PLANNING REPORT

Architectural Review Board

COhatch - Riverview Village 24-109ARB-PDP

Case Summary

East Elevation

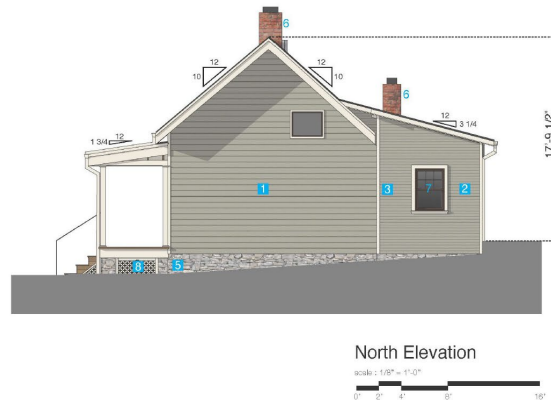
The applicant is proposing to repair and retain the structure mostly in its current form, except for the following modifications:

- Removal and replacement of the masonry deck and south porch with a new wrap-around porch. The new porch columns would be supported by masonry piers with lattice in between. The proposed roof pitch is $1\frac{3}{4}:12$, which is shallower than the minimum 3:12 required for porch roofs in §153.174(B)(4)(c)(3). Accordingly, a Waiver is required and is supported by staff.

- Replacement of a small addition on the west side of the existing porch (under the same roof) within the existing footprint. The addition would house mechanical equipment.

- Increase in the eave height at the rear additions to allow for better interior headroom. This would result in a shallower roof pitch of 3¼:12 requiring a Waiver from the 6:12 minimum pitch for principal roofs; also supported by staff.

- Installation of 3" horizontal cedar siding on the rear additions to provide a distinction from the wider siding on the original house.
- Extension of the eaves on the north and south sides of the original structure to fully define the gables at each end (the existing eaves currently merge with those of the rear additions).

- Some modifications to the window sizes and locations on the rear additions.
- Installation of a standing seam metal roof (DMI Dark Bronze). Even though the house most recently had asphalt shingles, older aerial photos show a standing seam roof.

- Installation of simple handrails at the porch steps.
- Repainting with SW 2821 Downing Stone (light gray) for the body and SW 7002 Downy (off-white) for the trim. It is not clear what the door and window colors would be.

- Per Chapter 4 of the *Historic Design Guidelines*, the existing doors and windows should be retained, repaired and reused if feasible. If replacement is necessary due to deterioration or ADA access requirements, then the replacements should match the existing ones as closely as possible. Specifications and details will need to be provided.
- The plans indicate that the lap siding on the north elevation would be replaced with 6" horizontal cedar siding to match the east and west sides. As noted above, Staff believes that the existing siding at that location adds character and should be retained/restored.

East Elevation

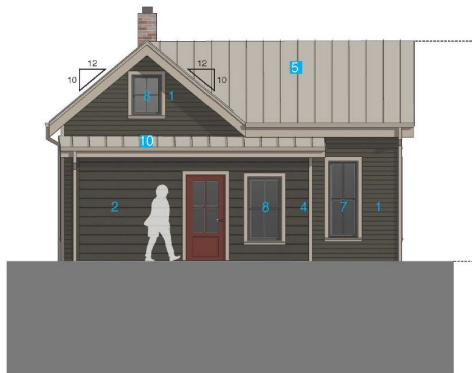
The applicant is proposing to renovate the house and keep its footprint intact. The following modifications are proposed:

- Removal of the aluminum siding and restoration of the original wood siding and trim.

- Removal of the front addition/porch and replacement with a more architecturally sensitive one. The front portion would continue to be an open porch, but with wood columns. The rest would take on the appearance of an enclosed porch, utilizing additional columns, taller windows and fiber cement trim boards. Stacked stone would be used for the foundation, with lattice under the open portion. Due to the needed headroom, a 1/2:12 roof pitch is proposed, requiring a Waiver.

- Increase in the eave height at the rear additions to allow for better interior headroom, resulting in a shallower roof pitch of 1 1/4:12 and requiring a Waiver.

- Replacement of the rear addition siding with 8" horizontal cedar siding.
- Elimination of one window at the rear addition and replacement of another window and a door with more architecturally appropriate ones.

- The application materials indicate that several tall 2-over-two double-hung windows would be replaced with 4-lite fixed windows. As noted above, the original windows should be retained, repaired and reused if feasible. If replacement is necessary due to

- The proposed 8" cedar siding on the north elevation is intended to help distinguish it from the principal structure. However, given the small size of this addition, the wide siding seems out of scale. Staff recommends that narrower siding matching the rest of the building be used at the addition, especially since its mass and location are subordinate and already distinguishable.

- Similar to 37 N. Riverview Street, the applicant intends to add roof insulation from the exterior (in order to expose the rafters on the interior). It is not clear how this would be accomplished while the existing roof is retained, but if implemented, it would result in wider fascia boards at the eaves. This increase should be minimized to the extent possible as it would alter the building's appearance.

- Staff would like to continue to work with the applicant on some refinements to the open/enclosed porch details.
- There is an opportunity to differentiate the window sash color from the trim as historically common. Matching the color of the door or lattice should be considered.

North Elevation

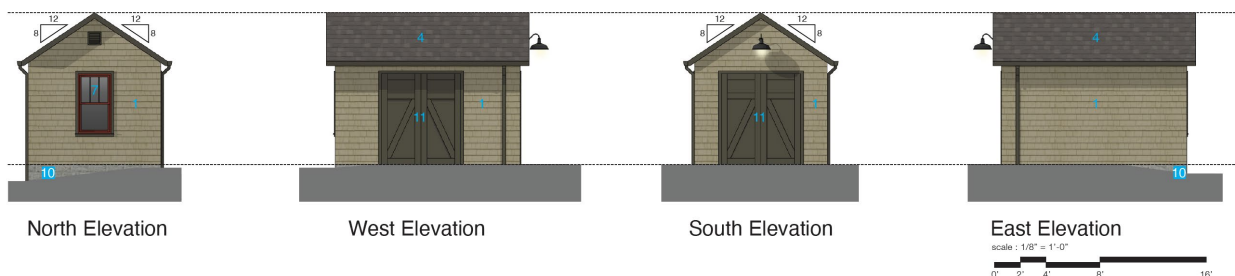
- Removal of the shallow roof element at the northwest corner (which contains hazardous materials) and its replacement with a mansard roof to help balance the appearance of the north elevation and allow for a taller ceiling inside. The roof pitch would be at 6:12, which is consistent with Code.

- Replacement of the front porch with a new one at the same location and with a similar overall design, except that the ceiling would be omitted and the gable would remain open, exposing the structural elements. This would help provide additional headroom. The porch posts would be tapered, consistent with some of the structure's Craftsman style elements. Pictures from the 1990s show slightly tapered posts (but to a lesser degree). Similar to the existing condition, the porch would rest on masonry piers with lattice in between.

- Switching the locations of the front door and the front façade's south window so that the door is centered on that elevation. The north window on that façade would be replaced with a double window.

- Relocation of a single window on the north façade so that it is centered under the gable, and replacement of a second single window with a double window.

- Expansion of a single window under the rear elevation's gable with a double window.
- Replacement of all windows (currently 1-over-1, double-hung) with new Craftsman style 3-over-1 double-hung windows.

Staff is supportive of the proposed modifications, especially since they are generally consistent with the early design supported by ARB at CP. This house was proposed to be demolished during the Informal Review process due to its poor condition and low ceilings. The alterations

- The current porch roof includes exposed rafters that extend to the eaves, along with some trim elements. Staff recommends similar treatment at the new porch.

- The existing window trim is simple but with a unique crown profile at the top. Staff recommends that this treatment be preserved where possible and replicated where needed.

- There are vents within some of the gables that should be maintained (consistent with §153.174(B)(7)(c)(1)).
- More detail is needed about the proposed rough concrete rockface proposed for the foundation. There might be an opportunity to obtain and install salvaged historic rock face concrete blocks instead.

- Ideally, the existing doors would be reused. If replacement is needed due to condition or ADA requirements, Staff would like to continue to work with the applicant on the door style. The front door at 17 N. Riverview Street is a good example of a simple door appropriate to the Craftsman style.

- More details about the windows will be needed.
- Staff recommends that corner trim not be used with the shake siding, especially since none currently exists.

- Staff also does not believe that engaged posts (half posts) are needed where the porch meets the front façade.
- Any increase in the roof fascia height should be minimized/mitigated.

Kiosk

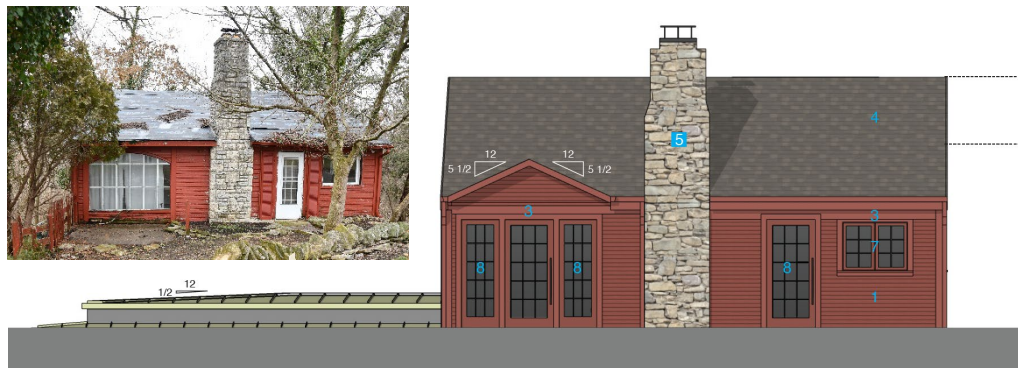
The kiosk design is currently at a preliminary stage and will be finalized at FDP. Staff is supportive of the design direction, which would help anchor the “village” and provide a focal element visible from various vantage points.
